**YAMAHA**

**PARTS CATALOGUE**

**GOLF CAR**

GOLF CAR 1985

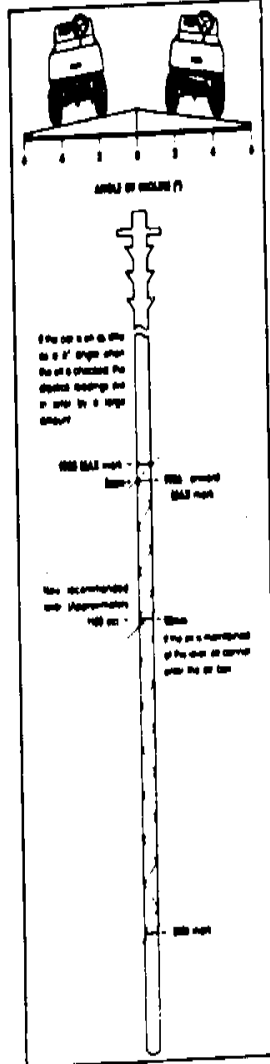
Customers should be cautioned that the oil level should be checked only when the car is on level ground. As seen in the illustration, with the car on as little as a 6° incline (normal road drainage pitch is about 4°), the dipstick can be easily misread.

By reducing the oil level in the engine to approximately 100 cc, this problem will no longer occur.

When adding or changing oil, the engine should be filled with 100 cc of oil. This amount lowers the oil level to a point on the dipstick between the MAX and MIN marks, about one-third the distance below the MAX mark (2mm). Do not fill above this point. This slightly reduced oil level will not affect lubrication. The oil level warning system still gives ample notice when oil must be added.

If desired, the dipstick can be remarked at the level indicated after an oil change. As usual, make sure both the dipstick and the oil-filter cap are firmly in place after any oil servicing to ensure proper circulation of oil in the cylinder head and that the governor is adjusted to factory specifications.

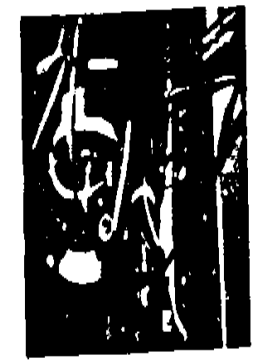
1. Open the seat cowl to gain access to the harness. Inspect the harness for any frayed or broken insulation or wires. If necessary, make appropriate repairs.
2. Position the wire harness, as shown, near the top of the frame tube, so it cannot be fouled.

NOTE: It may be necessary to loosen the nut that holds the positive (+) battery cable to the solenoid relay, rotate the L-shape, so cable terminal toward the rear to positive, the battery cable so it cannot be fouled, and retighten the nut.

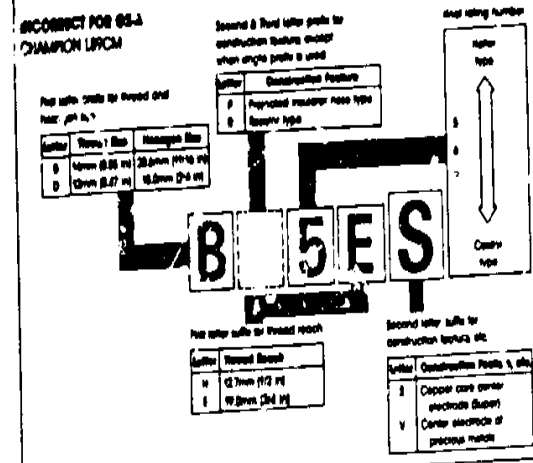
**INTRODUCTION**  
The CHAMPION spark plug used on pages 7-29 and 8-7 in the G2-A Service Manual is incorrect. The correct spark plug has a 3/4" thread reach and not 1/2" as listed in the manual. Performance is adversely affected by using the incorrect spark plug.

**AFFECTED UNITS**  
All G2-A (Starting I.D. J38-000101)

**HOW TO READ SPARK PLUG I.D. NUMBERS**  
If replacement of the spark plug is necessary, use the correct type/number/thread range as listed. Spark plug installation torque is 14 ft lb (2.0 Nm).

**CORRECT FOR G2-A**  
NGK B5ES or CHAMPION NS, NSC

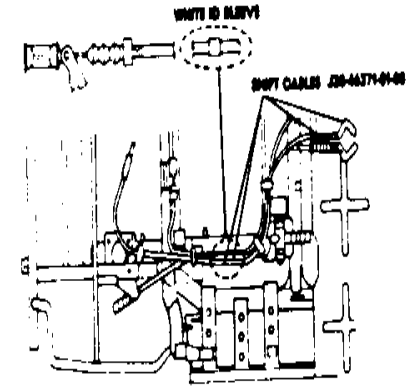
The improved shift cables will be crimped in YPI block as soon as current supplies are depleted.  
The part number of the improved cable remains the same. However, a white sleeve has been placed around the outer cable to identify the improved version.

## PLUNGER ADJUSTMENT (Cont'd.)

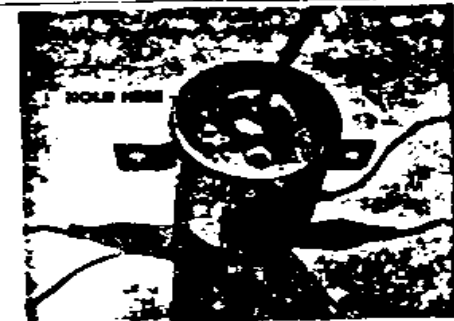
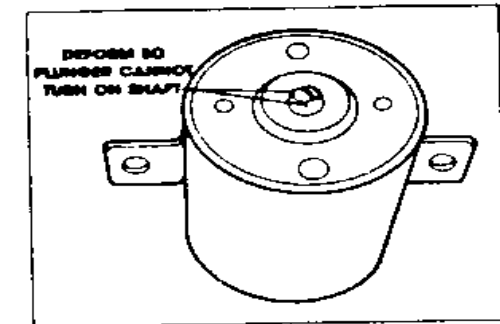
- Hold the plunger so it does not turn. Insert a screwdriver into the slot in the shaft, and turn the shaft clockwise until the needle on the tester just starts to move. Then, turn the shaft another 1 ± 1/8 turn clockwise. This will set the plunger so there is about a 1mm overstroke. The ohmmeter should read zero. Disconnect the battery and meter leads.

- Slide the shaft screw slot by squeezing the collar around it in a vise or with a pair of pliers to prevent the shaft from turning.
- Install the collars, the plate, the screws, and the rubber cover.
- Reinstall the solenoid, and check solenoid operation.

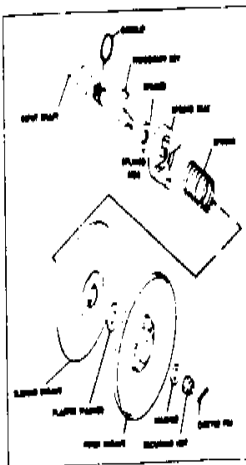
**REMEDY** Replace the spring seat circlip with the new spacer.

- Follow service manual instructions to remove the rear body and the secondary clutch fixed sheave.
- Remove the plastic washer, woodruff key, sliding sheave, and spring seat. Remove the circlip. Tag the circlip with a Warranty Parts tag and hold for 90 days from the date the Warranty Request is submitted. The circlip is not used with the new spacer.
- Install the new secondary sheave spring seat spacer on the input shaft with the inside splined side of the spacer towards the spring seat. **DO NOT REINSTALL THE CIRCLIP.**
- Reinstall the secondary spring seat and reassemble the secondary sheave assembly according to the service manual procedures. Use a new cotter pin.

**NOTE:** Pay special attention to the service manual procedures for installing the spring and sliding sheave. Correct installation of
